AUTOMATIC TRANSMISSION SERVICE GROUP

**REVISED EDITION**

Since the introduction of the THM 440-T4 Transaxle in April, 1984, there have been many major engineering design changes. These changes have affected nearly every part used in the THM 440-T4. This Update Handbook will explain each change, the parts affected by the change, and any parts interchangeability problems created by the change.

Figure 54

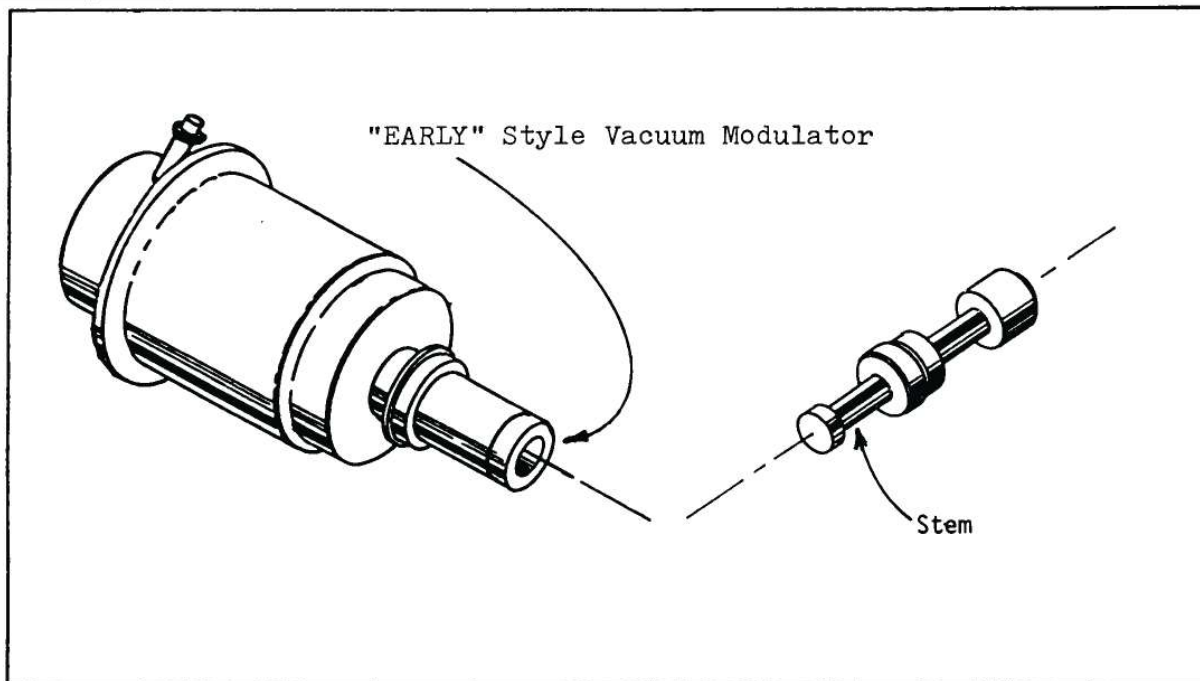
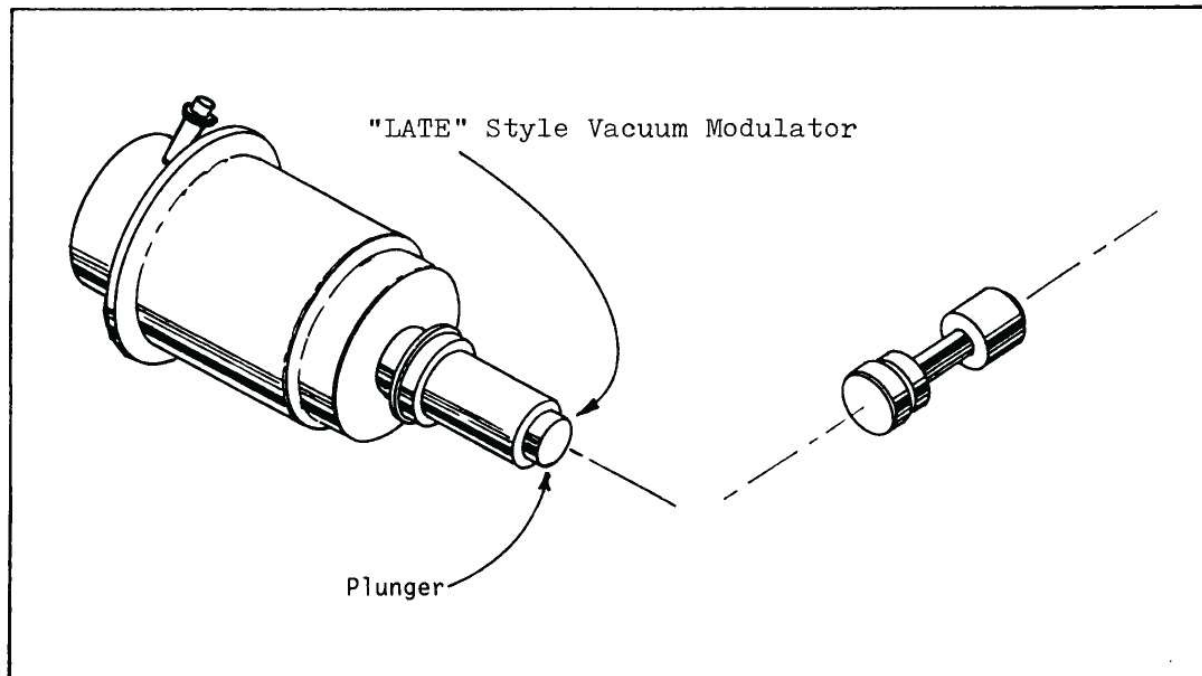
Change: Modulator redesigned on the end that goes into transaxle.
(Compare Figures 54 and 55). Occured Approx. July, 1986.

CAUTION: Be certain, if changing modulators, that you have compatable parts together. You cannot install the late style modulator on top of the early style valve, but you can go the other way very easily.

Figure 56

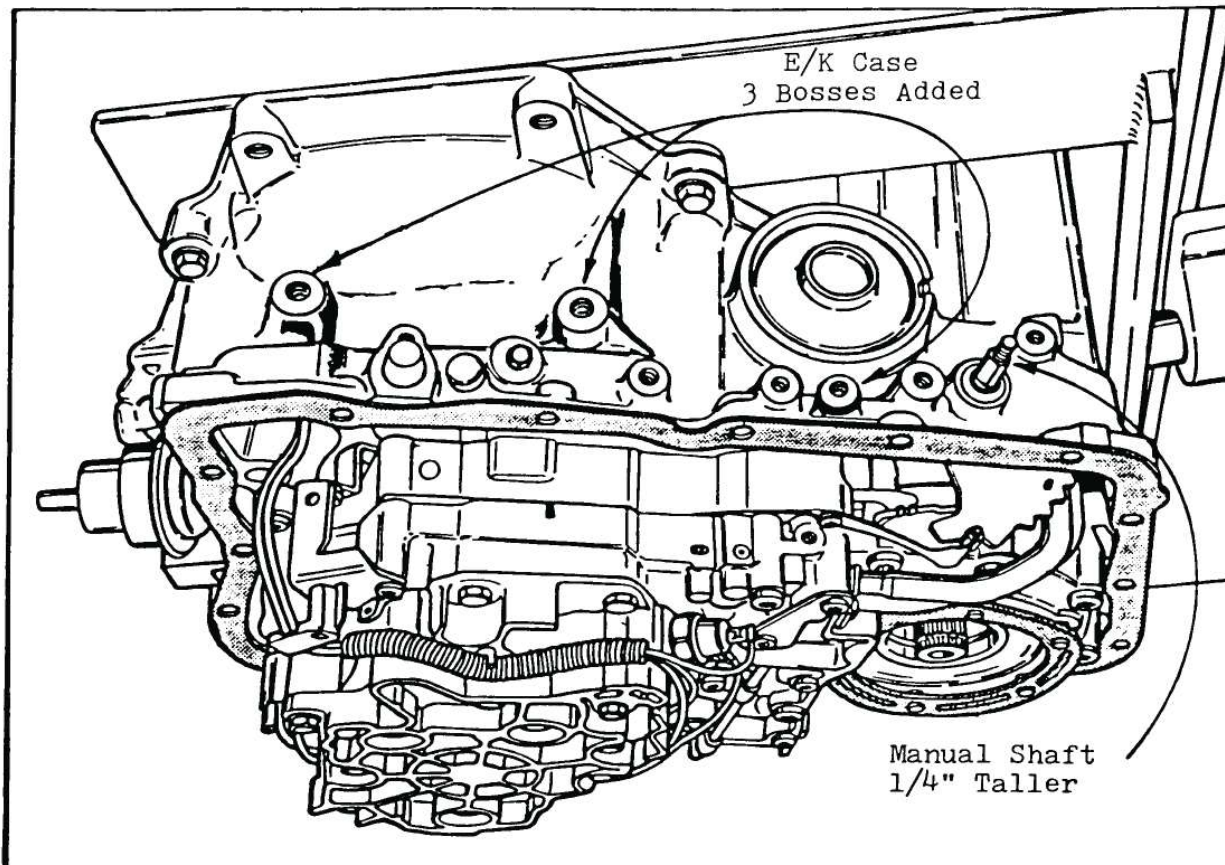
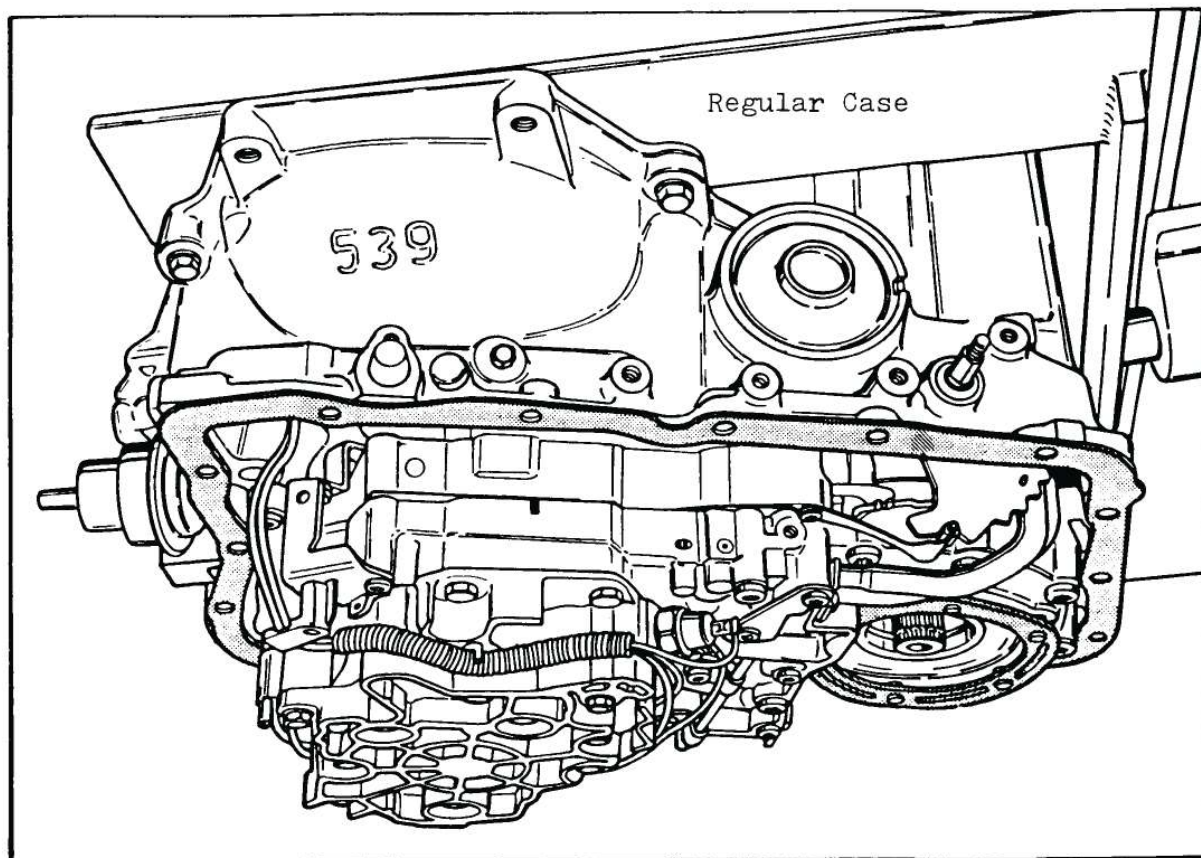
Change: Transaxle Case Assembly - 3 bosses added to transaxle case assembly (See Figures 56 and 57).

- 1) Transaxle Case - 3 bosses added to the case assembly (See Figures 56 and 57). The larger bosses on top of the case are for mounting purposes in the "E" and "K" bodies only. The smaller boss is for fuel line bracket in the "E" and "K" bodies only (See Figure 56). We can immediately see why it is called the E/K case.
- 2) Manual Shaft - The manual shaft is 1/4" longer on the E/K cars only.

Figure 62

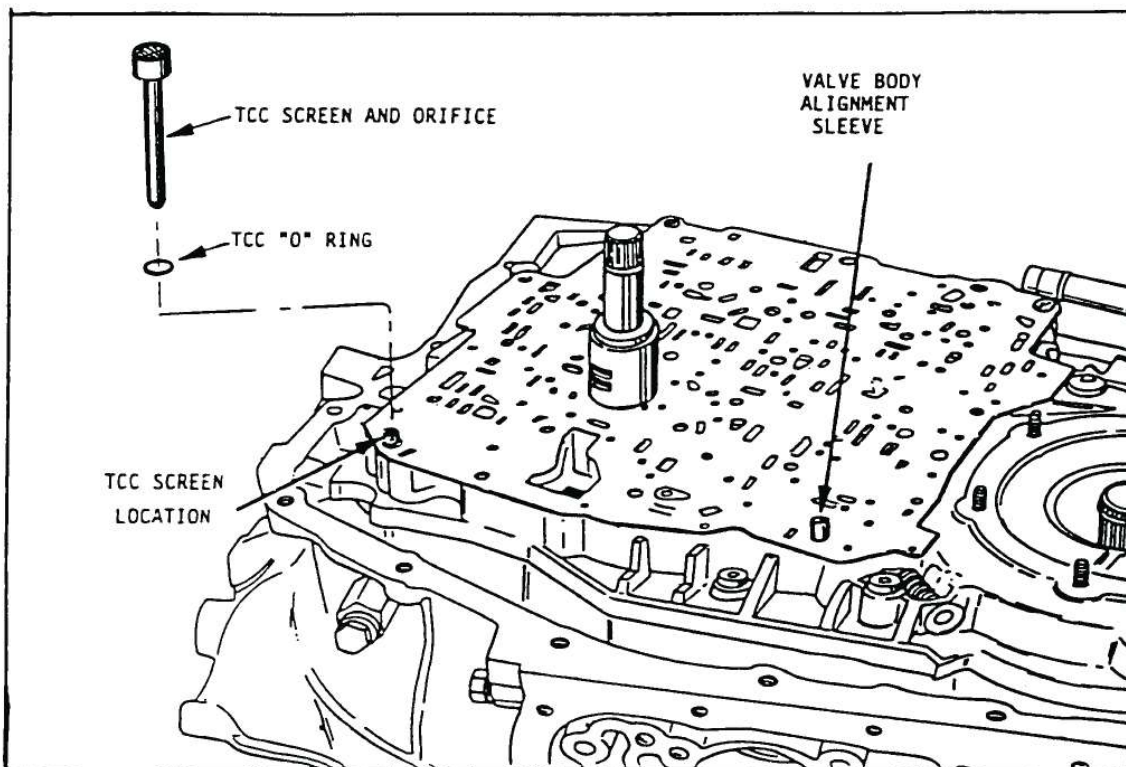
CAUSE: The cause may be a missing TCC screen and orifice (See Figure 62). If the TCC screen and orifice are left out of the 440-T4, the converter clutch will apply on the 1-2 shift because of the solenoids inability to exhaust TCC signal oil there by stroking the lock-up valve. The TCC screen and orifice must be in place, as well as the "O" ring (See Figure 62). The TCC screen "Snaps" into the spacer plate.

CORRECTION: Install the TCC screen and "O" ring into spacer plate in location shown in Figure 62. First install "O" ring on TCC screen and then "Snap" into place in the spacer plate. OEM part numbers as follows;

Figure 68

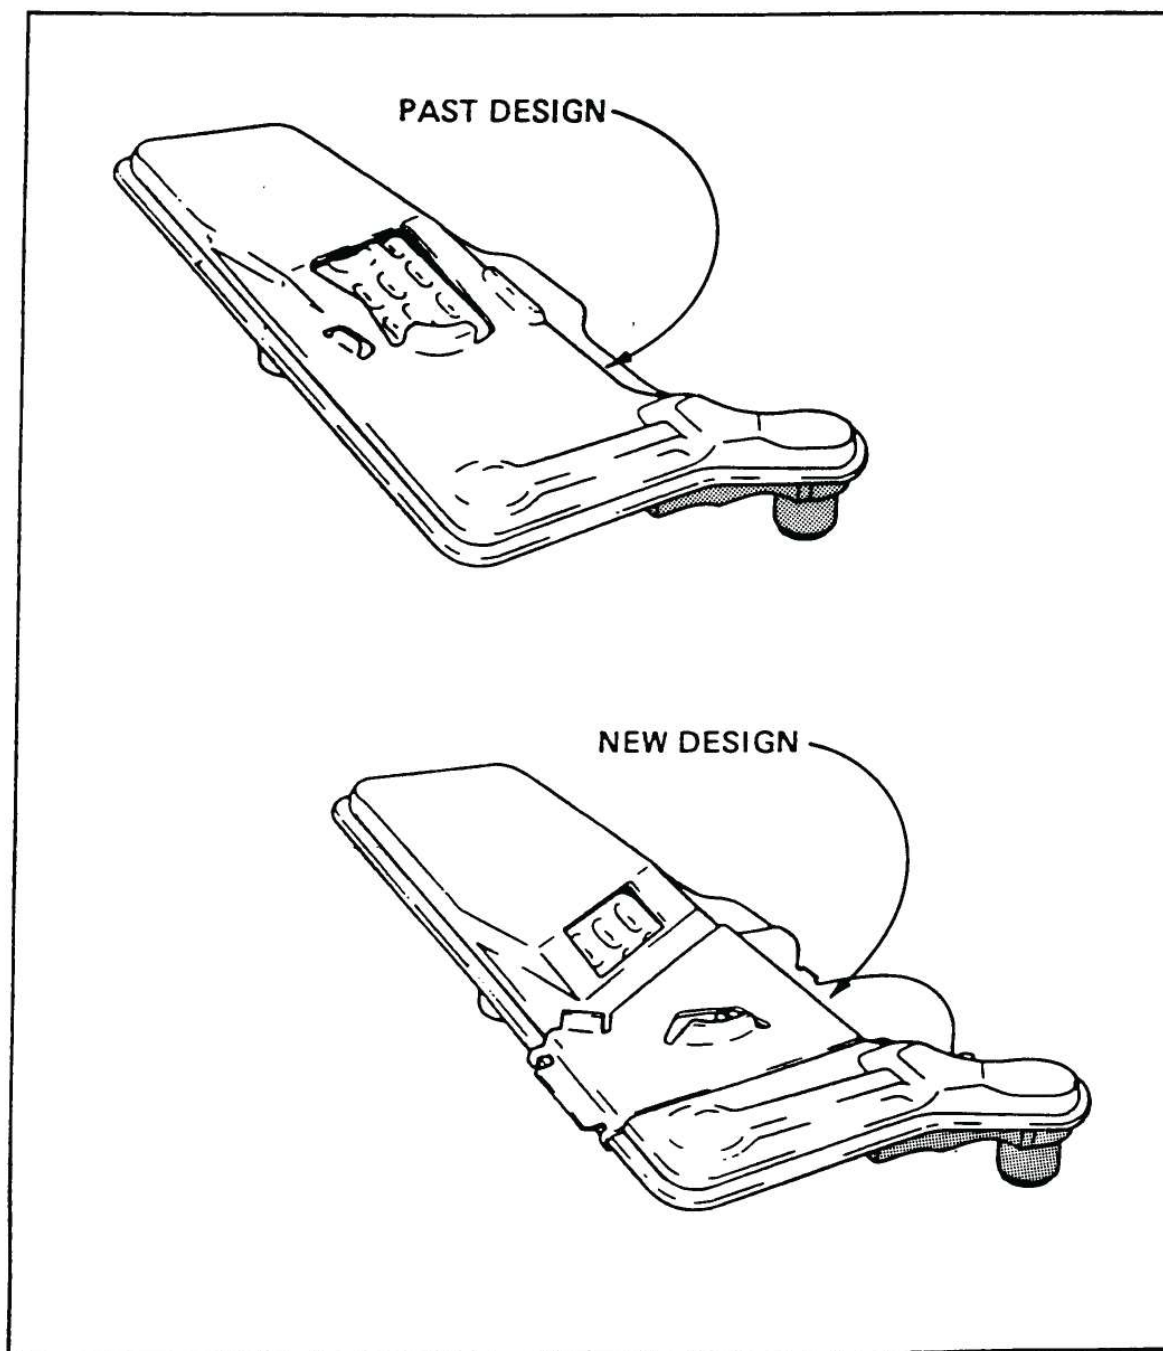
CHANGE: Oil Filter Assembly - Added baffles to oil filter and revised inlet (See Figure 68).

Additional baffles were installed on the new design filter and the inlet was revised (See Figure 68). Starting April 6, 1987 (Julien Date 096), all THM 440-T4 transaxles were built using the new design filter with the new inlet and baffle design.

Figure 69

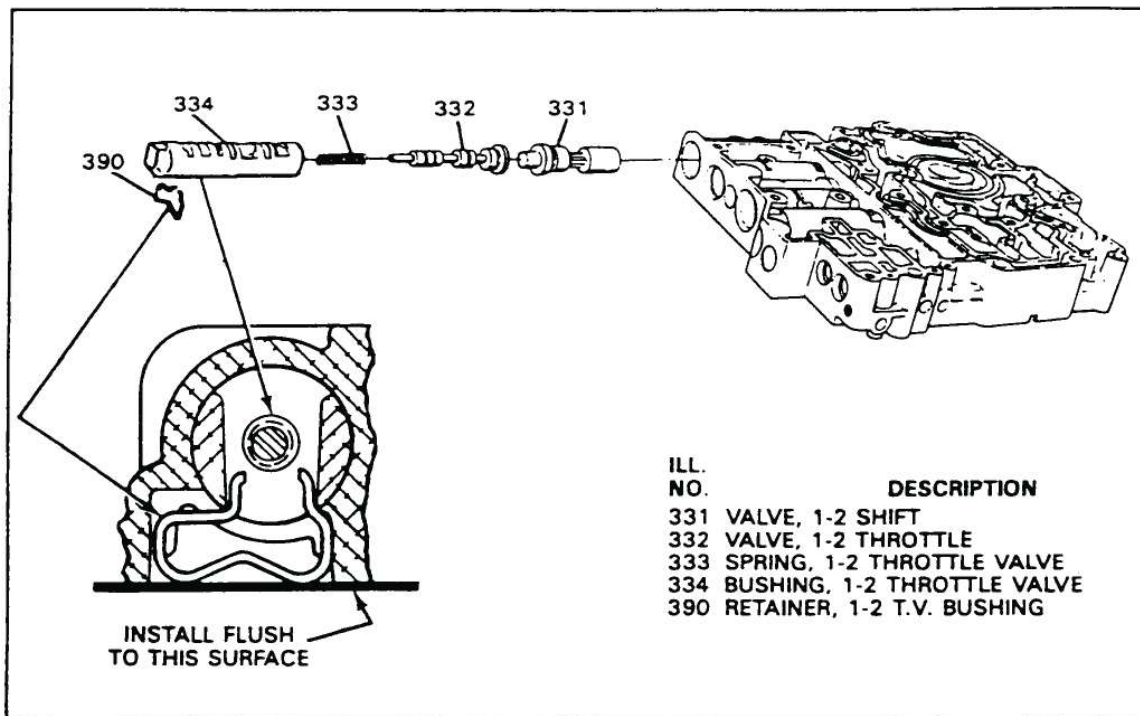
CAUSE: The cause may be the 1-2 throttle valve bushing retainer (390) pushed in too far (See Figure 69). If the retainer is pushed in too far the "Legs" of the retainer will grab hold of the 1-2 throttle valve, and the result will be 2nd gear starts.

CORRECTION: Install the retainer so that it is flush with the machined surface of the valve body (See Figure 69).

NOTE: The bushing must be installed as shown in Figure 69, with the angled surface on the end of the bushing toward the channel plate.

Figure 70

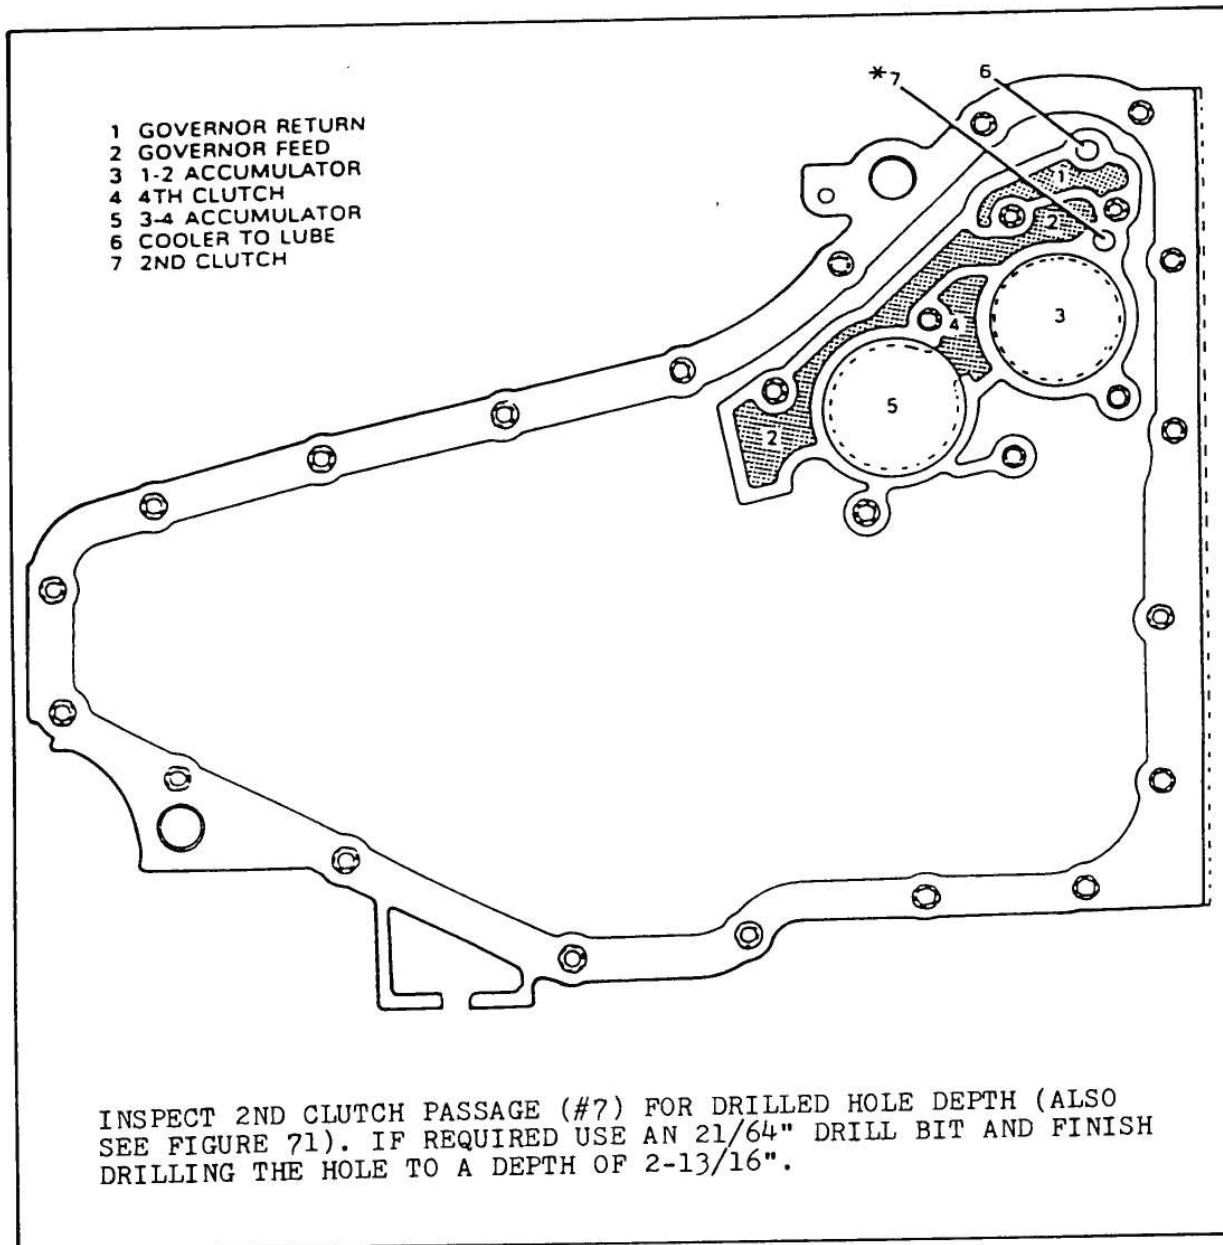
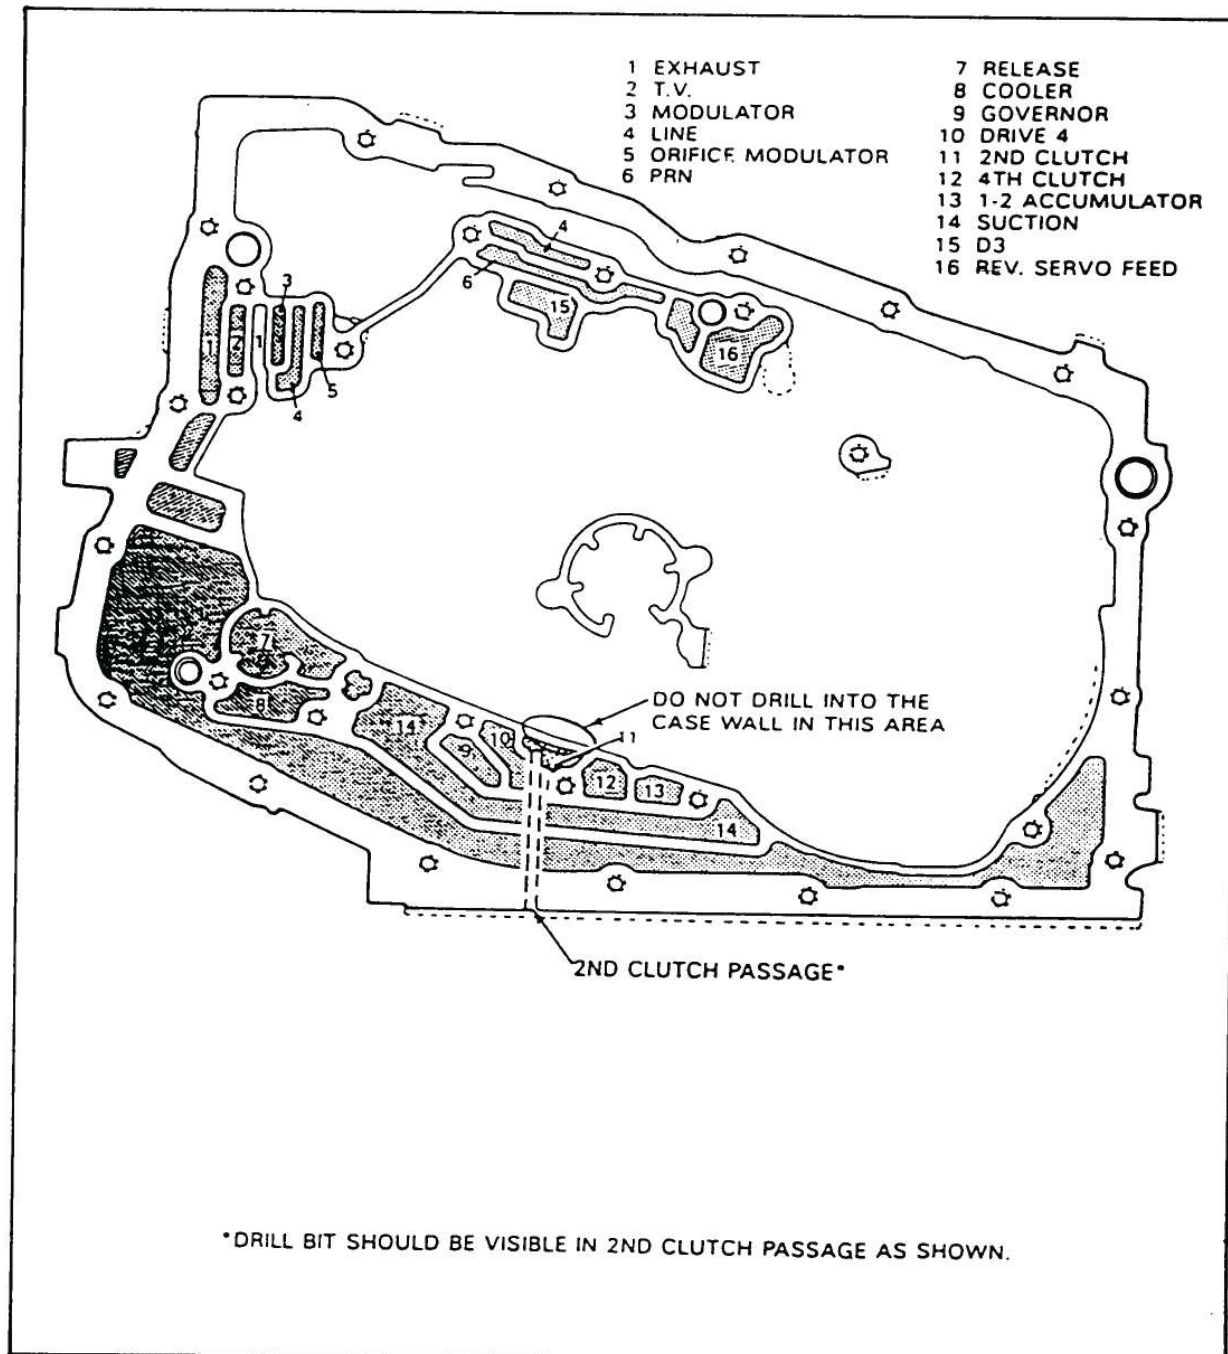
CORRECTION: To repair this condition inspect the 2nd feed passage, #7 in Figure 70, for blockage or incomplete drilling operation. To perform this inspection, remove the transaxle oil pan, filter, accumulator cover (With feed pipes and retainer), accumulator cover spacer plate and gaskets. Inspect the 2nd clutch passage by measuring the depth of the hole, which should be a minimum of 2-13/16" as shown in Figures 70 and 71.

1. Remove the transaxle from the vehicle and disassemble components up to and including the channel plate.
2. Mark a 21/64" drill bit at 2-13/16" from the end using a drill stop or tape. From the oil pan side of the case, finish drilling the 2nd clutch passage to the proper depth as marked on the drill bit.
